Proposed Revisions to a Standard Plans Index

Index Number: 521-010

Index Title: Opaque Visual Barrier

Summary of the changes:

INDEX	SHEET
521-010	1 of 2

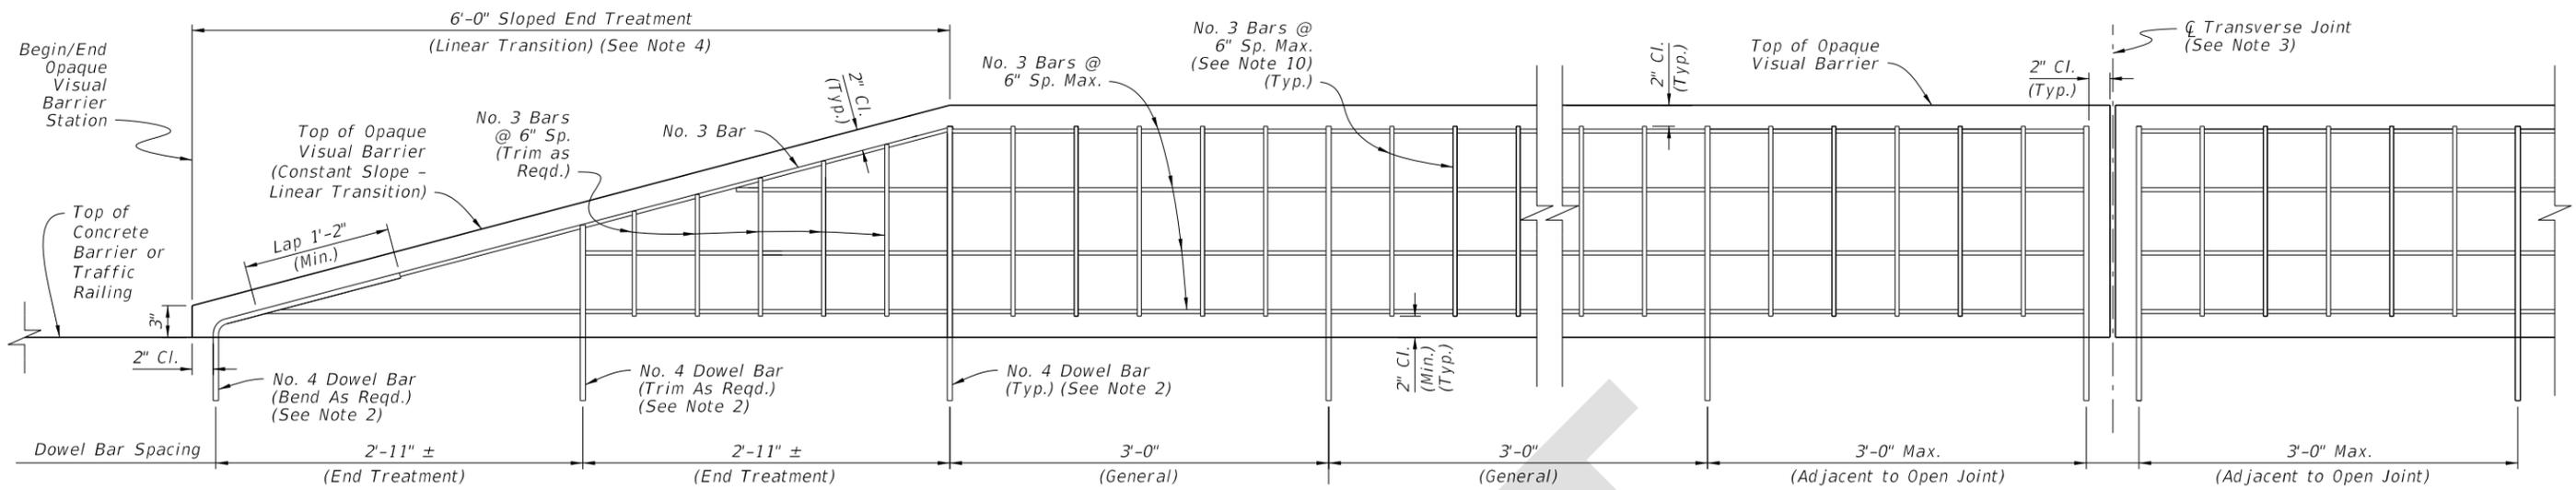
Sheet 1: Section Views - Added barrier delineator placement details and callout; Note 9: Added explanation for how to locate barrier delineators with split barrier sections.

Added detail to clarify placement location of barrier delineators when an Opaque Visual Barrier blocks the standard placement location on top of the barrier.

Added Barrier Delineator placement instruction

Added Barrier Delineator Detail

ELEVATION VIEW - OPAQUE VISUAL BARRIER

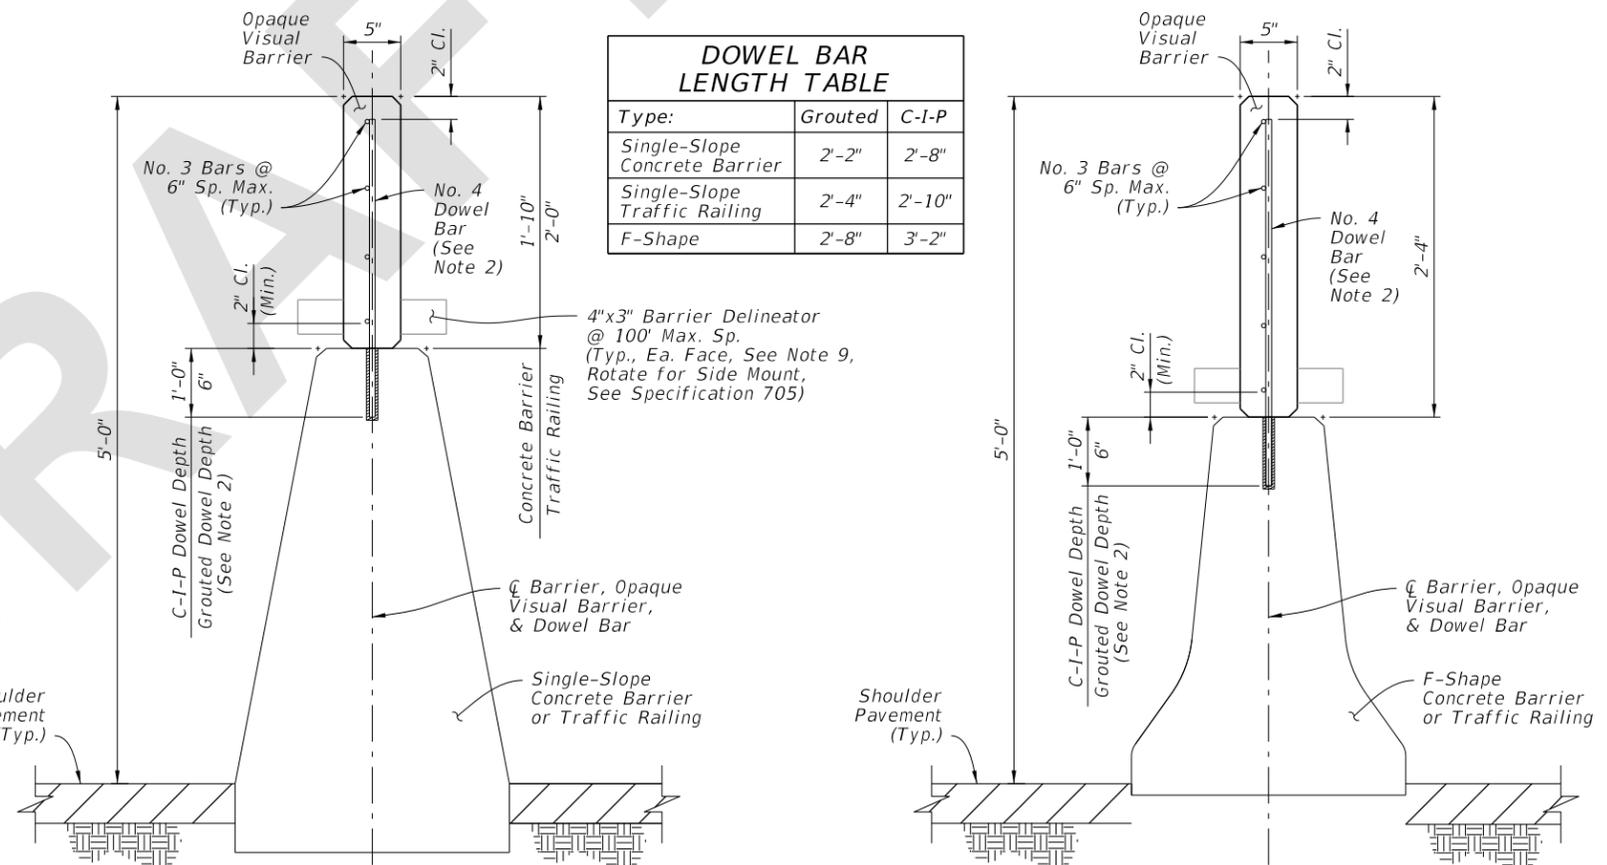
9. SPLIT CONCRETE BARRIER SECTIONS: For split Concrete Barrier sections that run separately (for vertical structures, bridges, etc.), OVB is only required on top of one of the Concrete Barrier sections. Place OVB on top of the Concrete Barrier section with the highest elevation. For these segments, mount barrier delineators on only the OVB face nearest the roadway (barrier mount other side). Longitudinally overlapping OVB runs are permitted where called for in the Plans, as designated with overlapping Begin and End Station OVB callouts.
